## Service data bulletin

Instrument: GDS101  
SDBGDS101\_33 Burned resistors on terminal PCB

### BURNED RESISTERS ON TERMINAL PCB

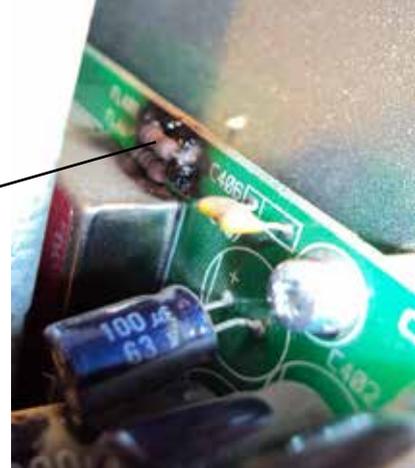
Fault description: FL406 and FL407 are 10 Ohm resistors on "Terminal PCB". (See below pictures)  
They are installed in 48V power to transducer. Some of these resistors have become overheated after a few years of usage.

How to fix: A damaged (short circuit) transducer or heavy load on transducer may be the cause of damage.  
Set "FIX RANGE ON" in "Screen 9". This will inhibit the heavy load of looking for bottom outside the set "range" when vessel is sailing in open sea for days.

If PCB is burned then change complete PCB. Part number PT-G041 (GDS101 colour).  
If PCB is not damaged it should be possible to replace the resistors with locally purchased 10 Ohm 2 Watt resistors.

Example for correct mounting resistor with long leg for better cooling / air circulation
